City of Woodland

Planning Commission

Thursday, March 3, 2016

Lennar; The Crossing at Spring Lake

A-18
0 2 4 8 12
01/12/16 | # 15048

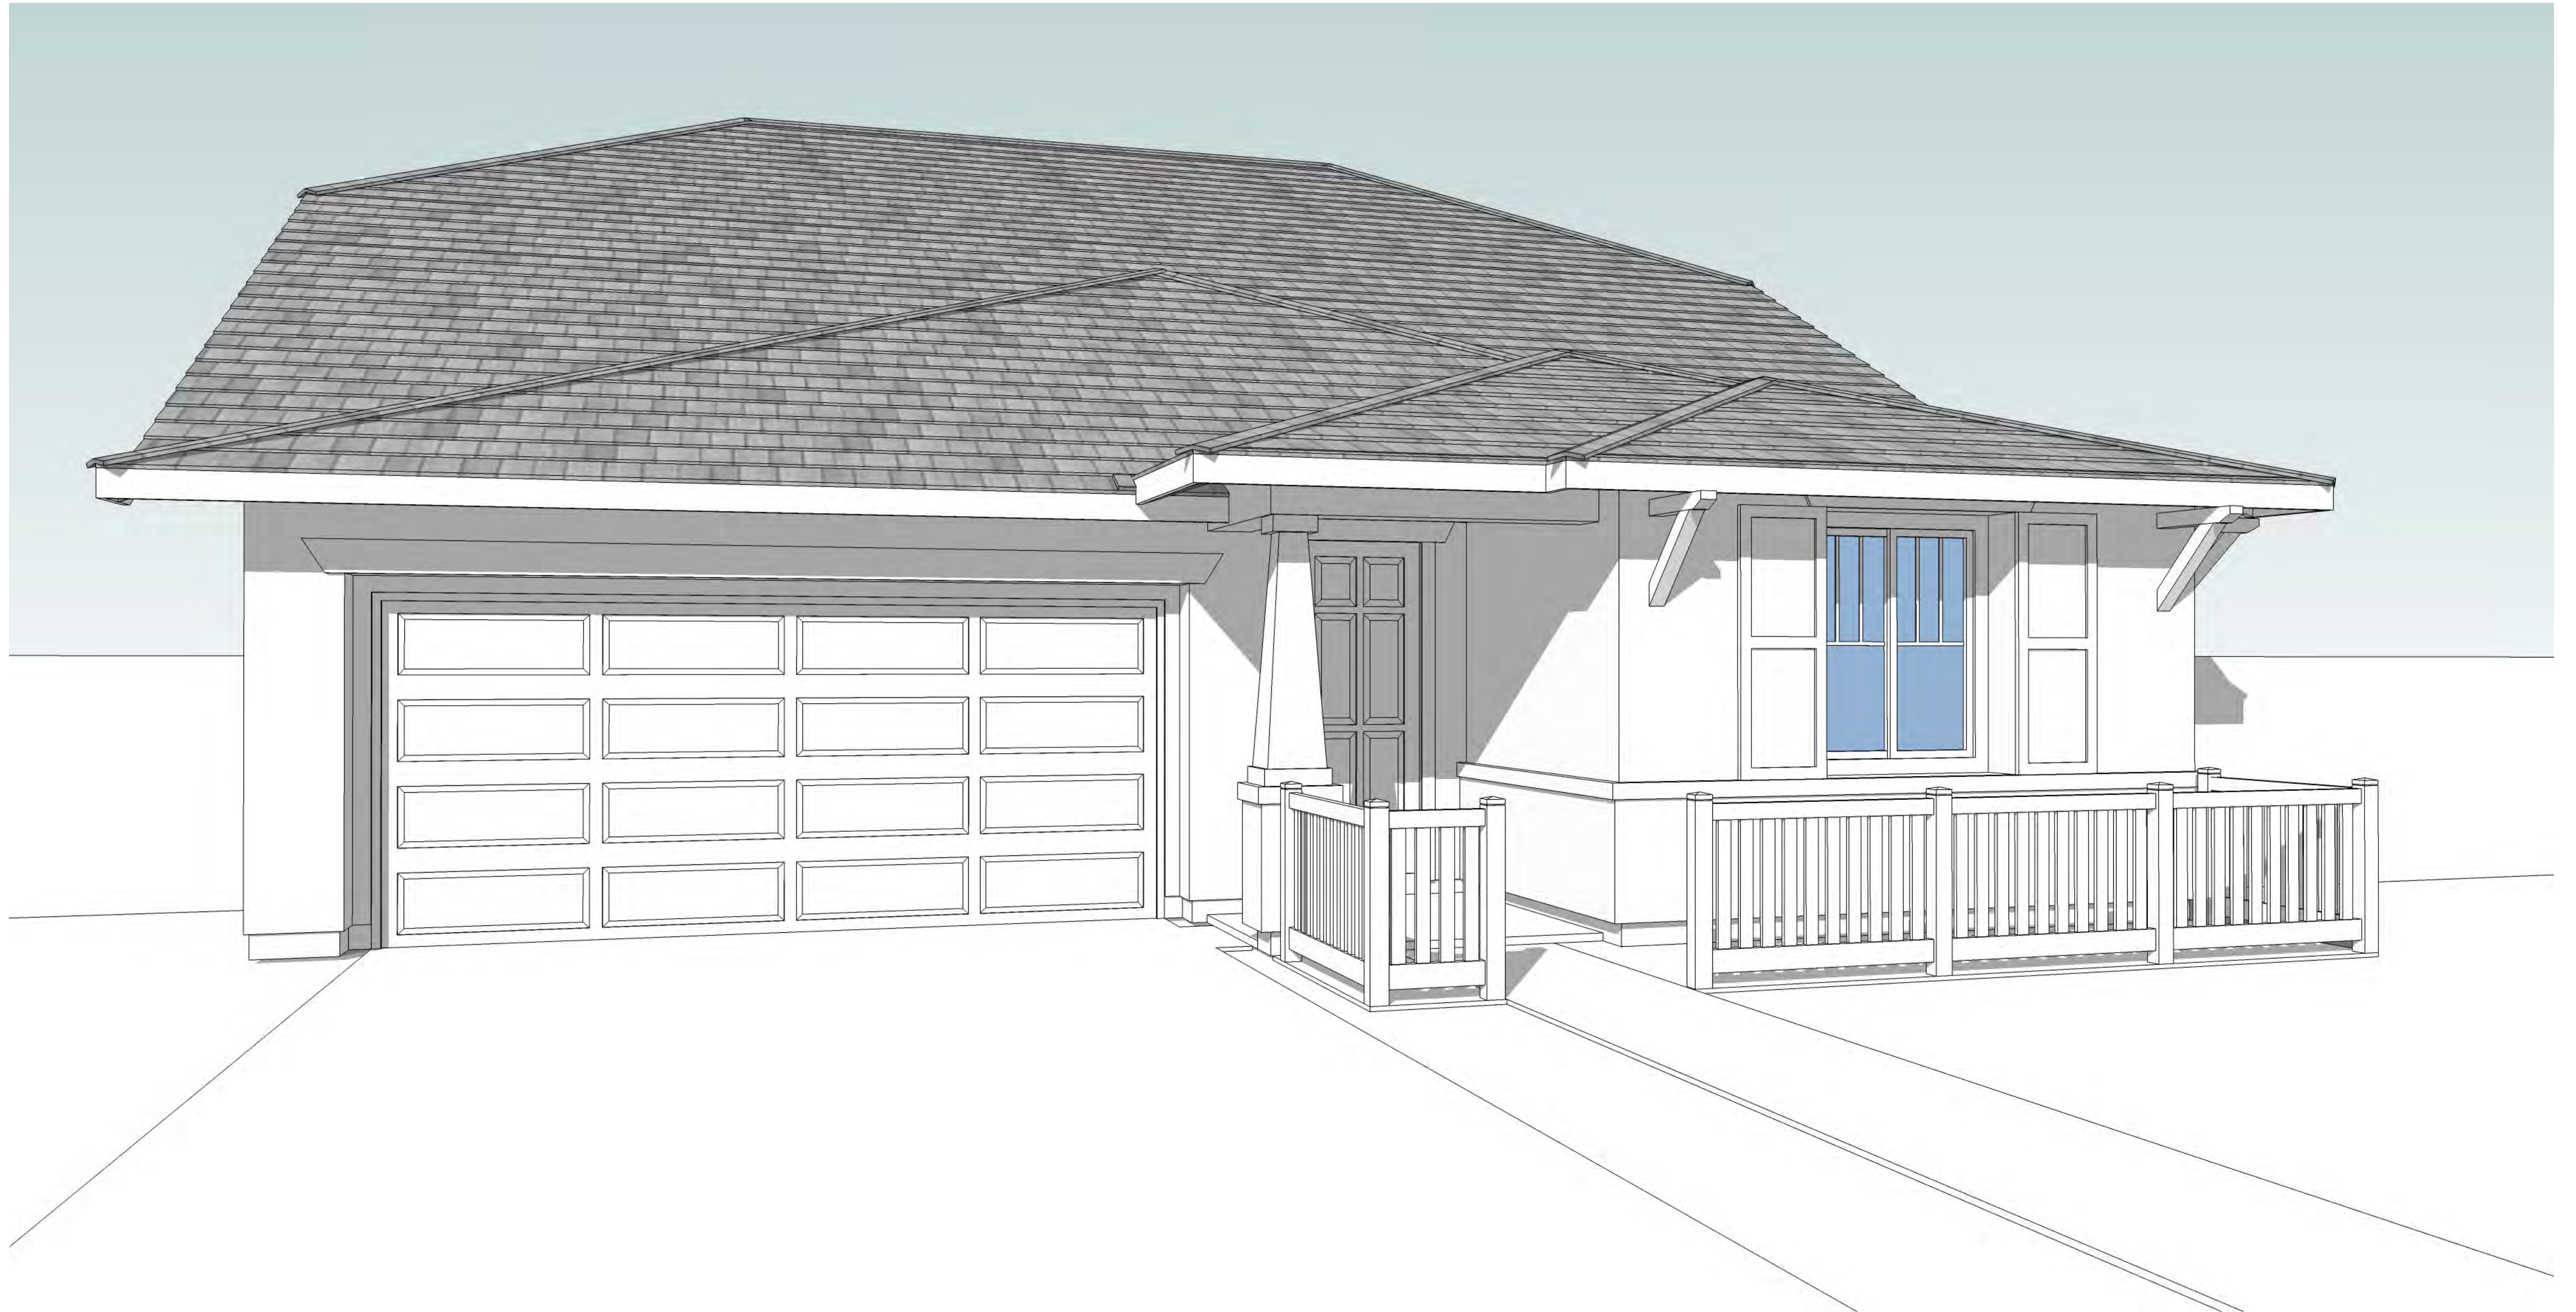
In response to Staff's concern about the potentially large magnitude of the roof for Plan 2119, the applicant provided a rendering showing what the Prairie design of this Plan would look like (see Sheet A-18 of Attachment 2). Plan 2119 includes a loft area as well as an area where the ceiling on the second floor is open to the first floor area.

PLAN 2461

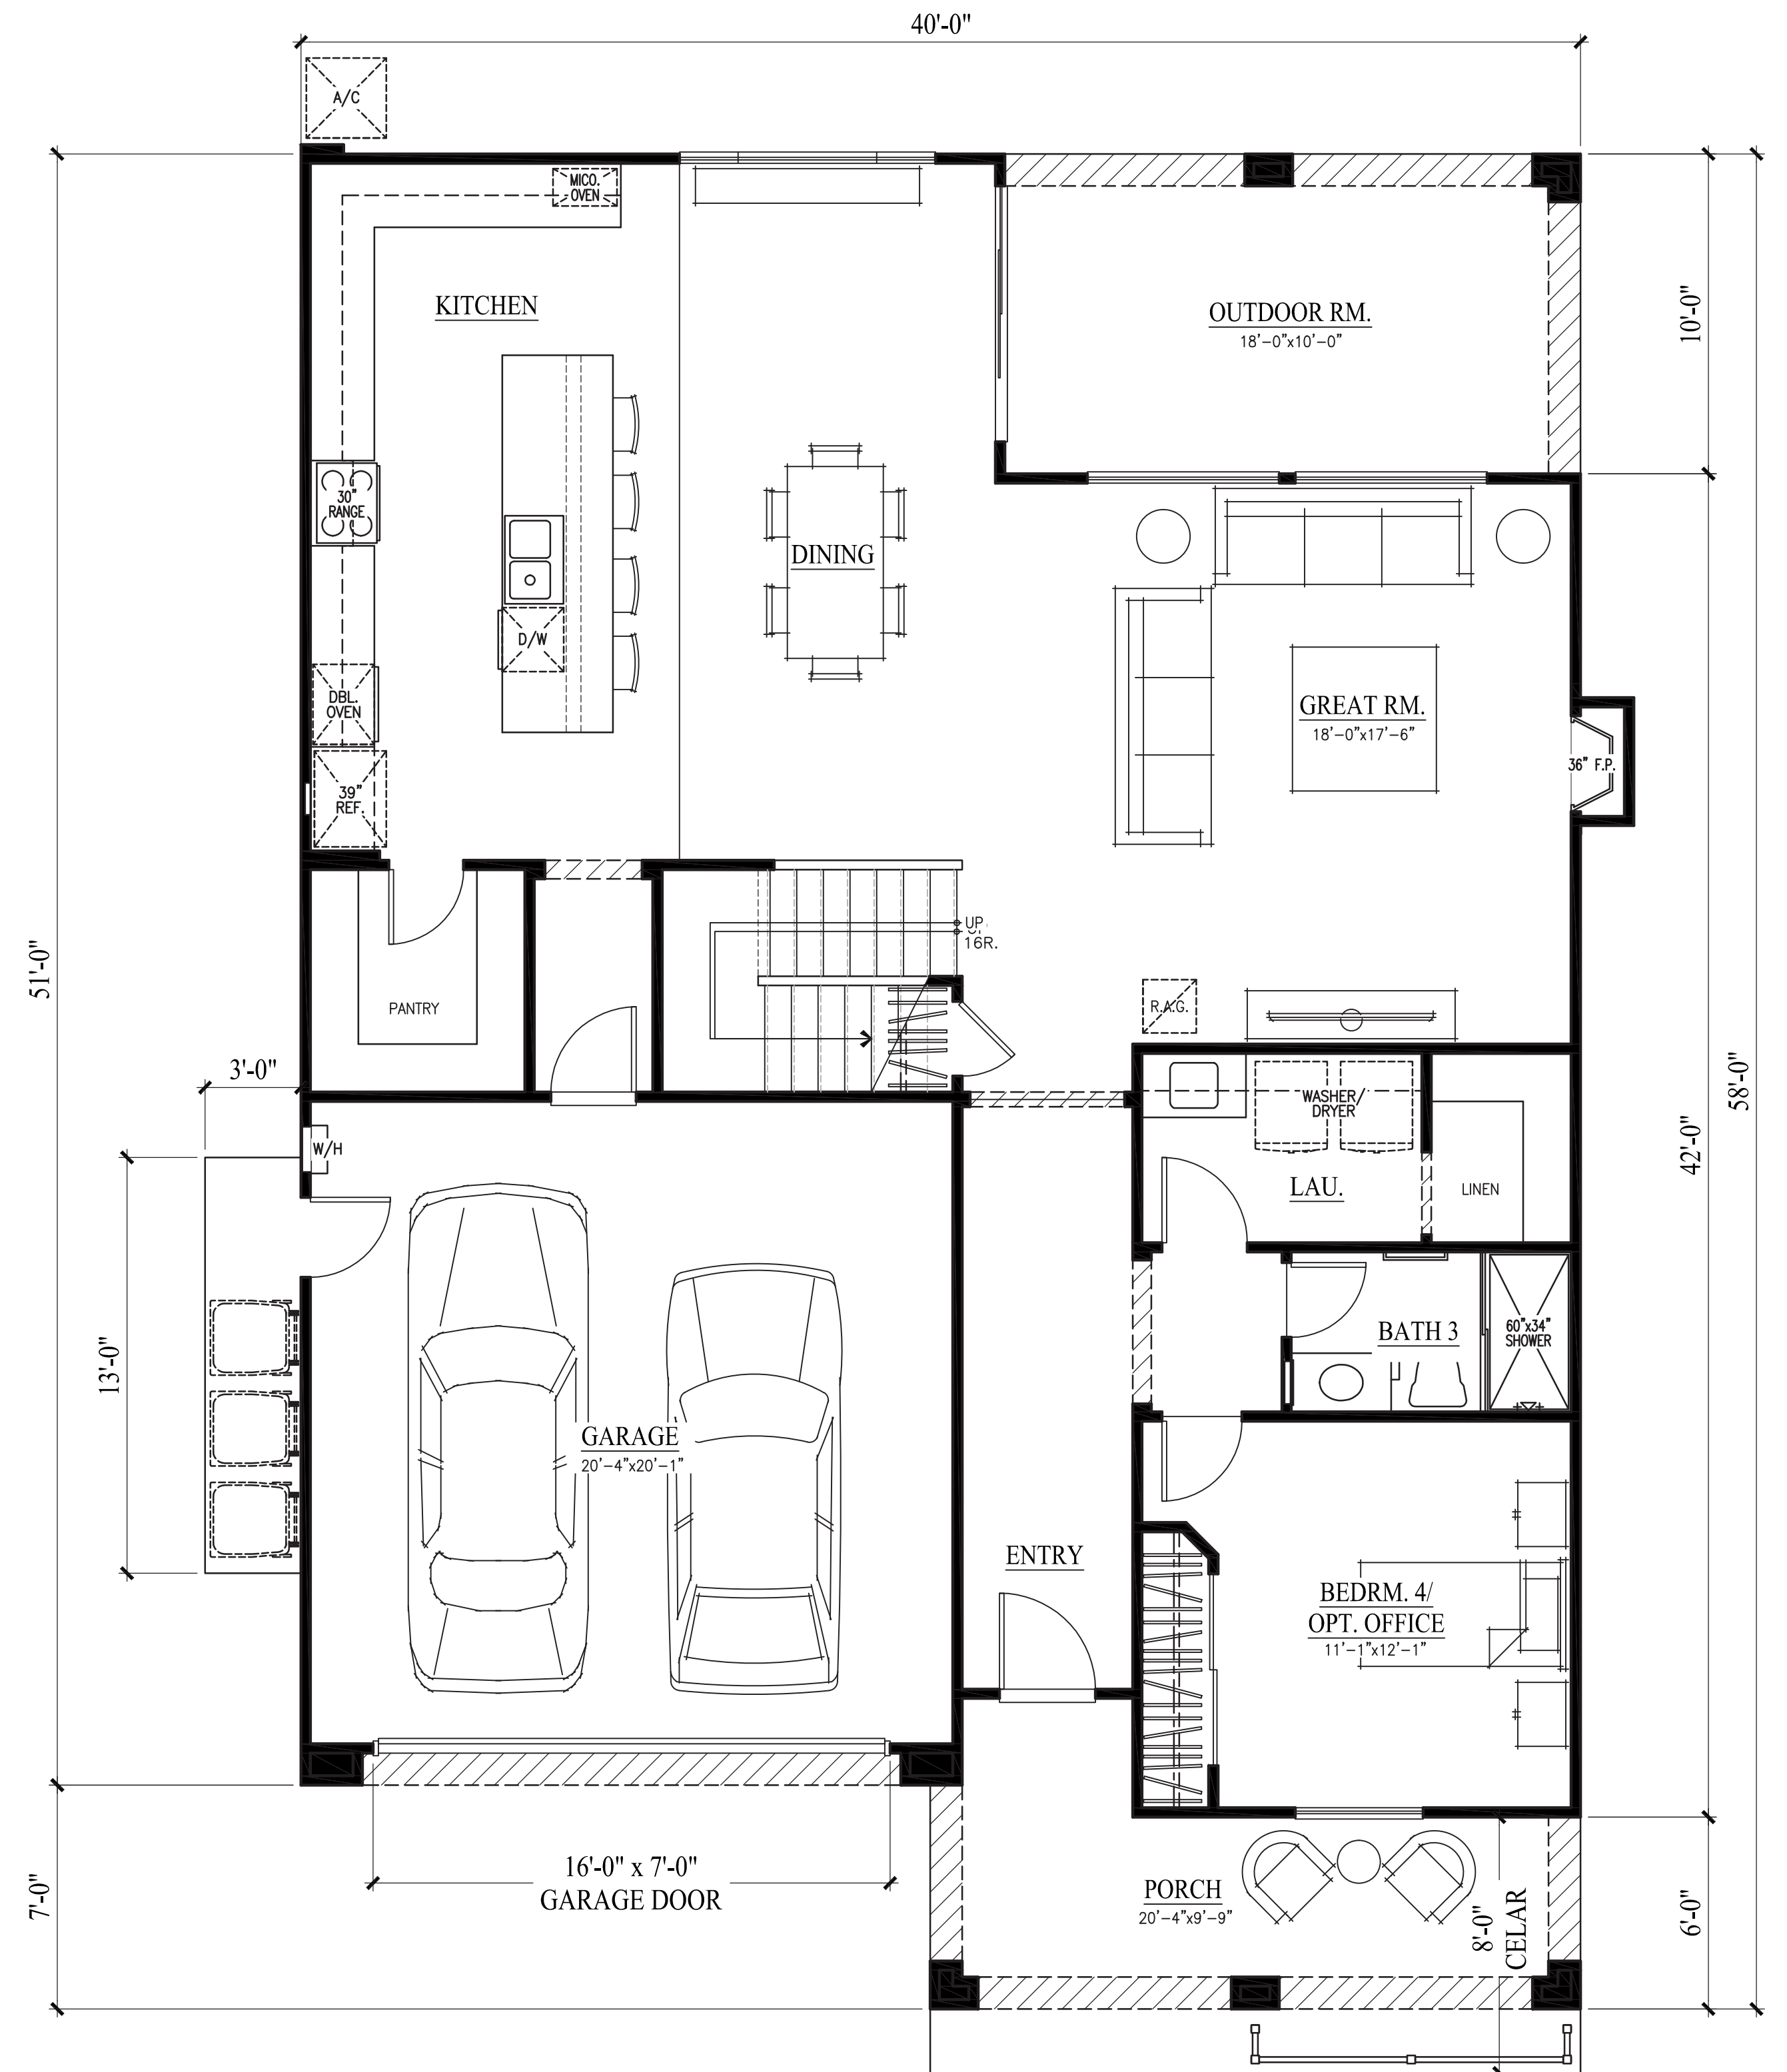
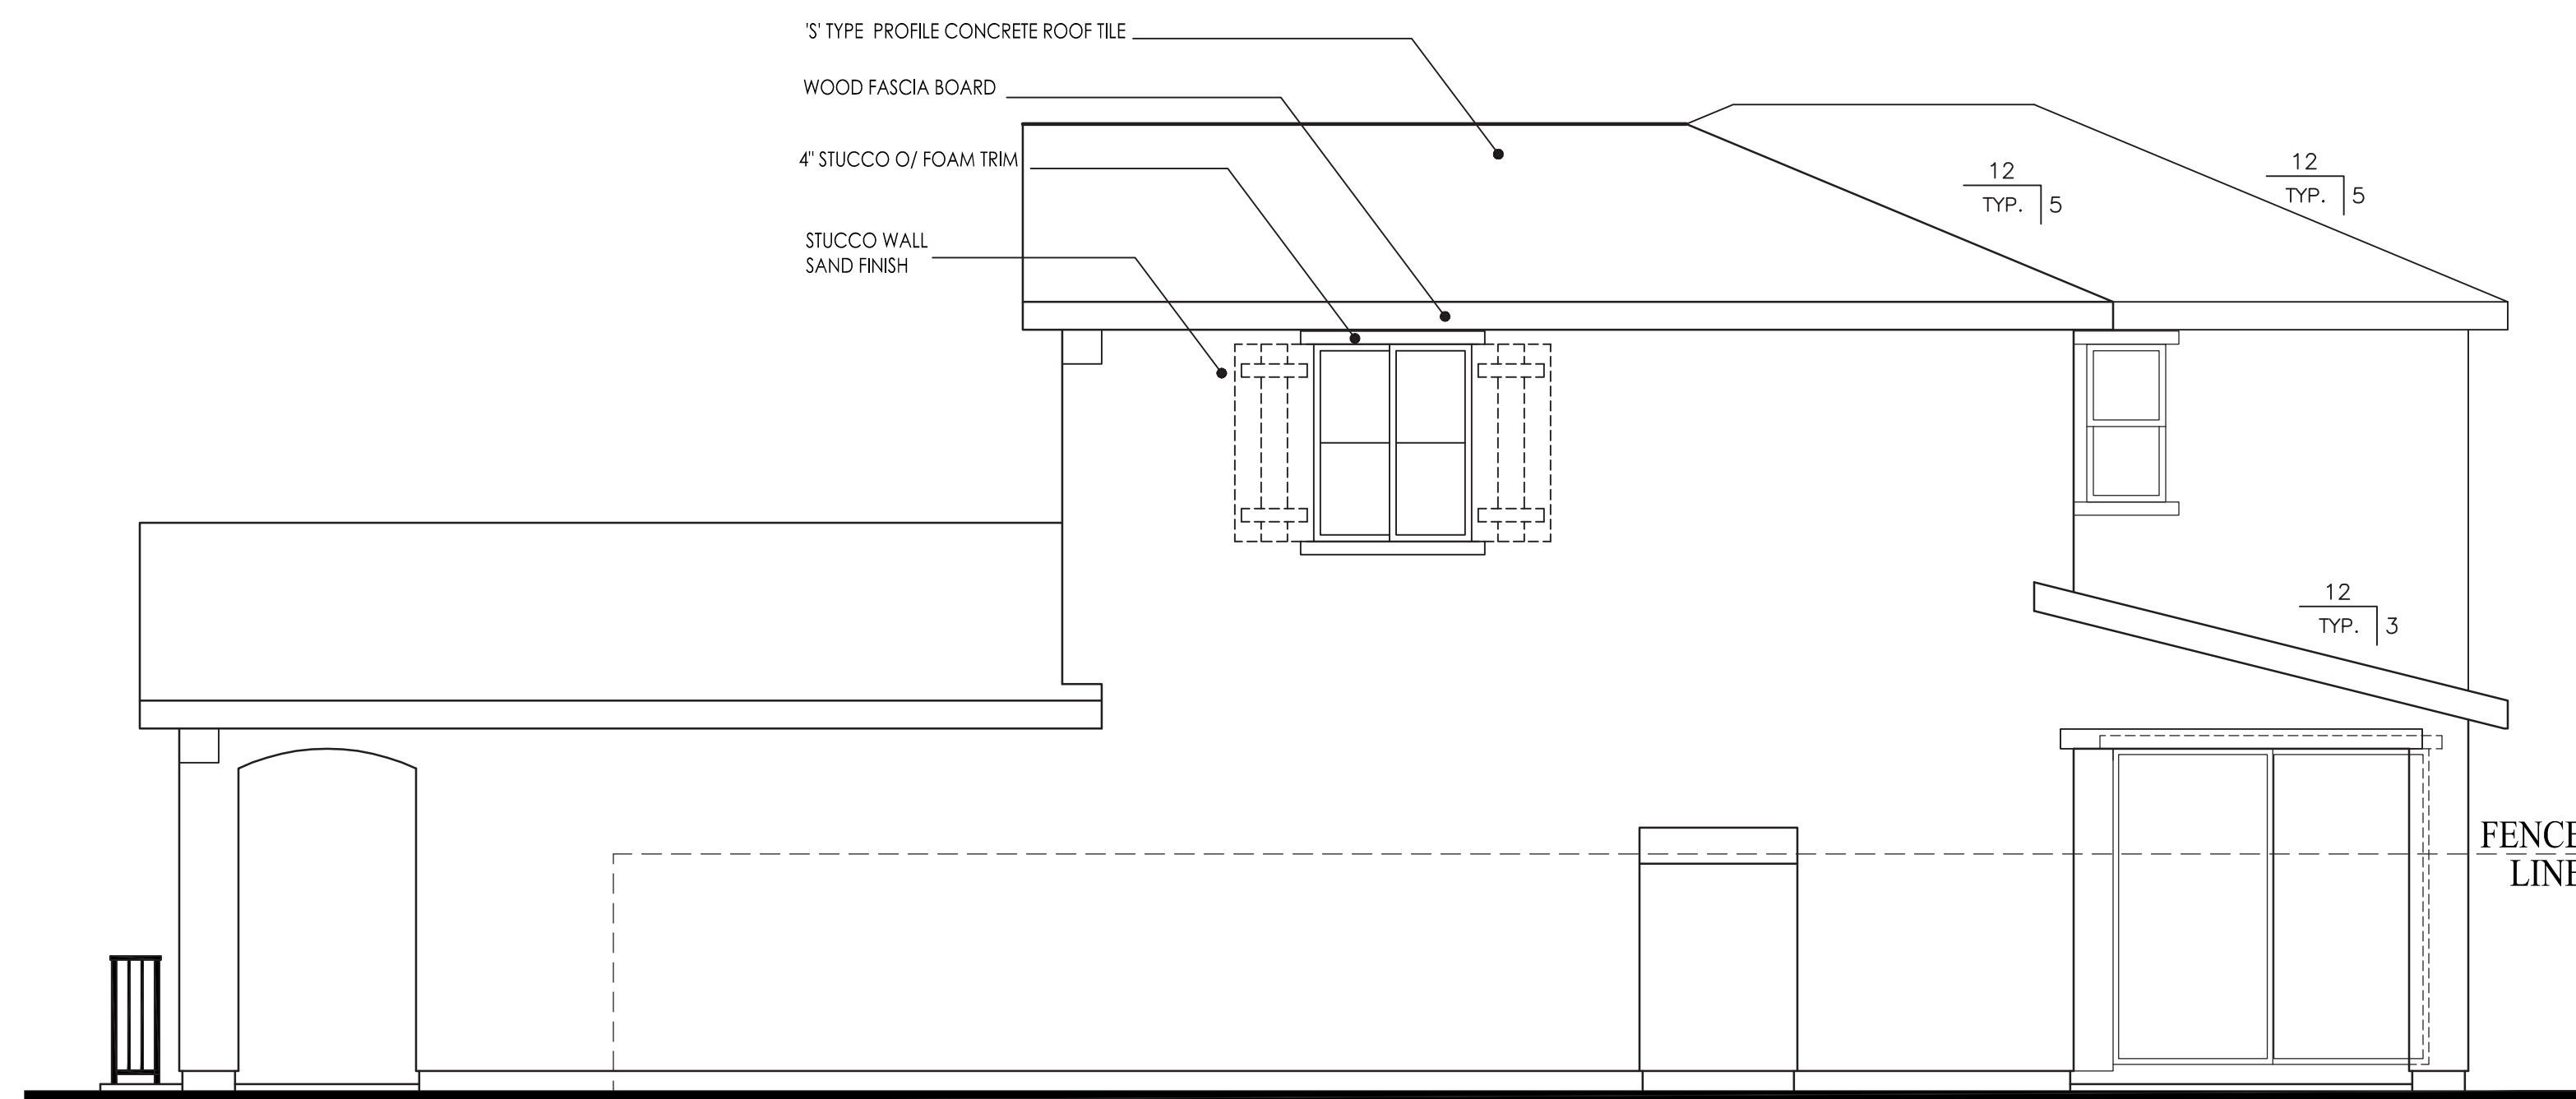
increased porch areas can be achieved while respecting other requirements such as setbacks and lot coverages. A condition of approval (COA #3) has been added to address this matter. The plan submittal includes a variety of garage door designs, driveway patterns, as well as varying roof pitches. Roof pitches range from 3:12 to 6:12.

- COA #3** Prior to issuance of building permits the applicant shall work with Staff and the Design Liaison in the design of the front porches for Plans 2461 and 2713 to substantially meet minimum size requirements.
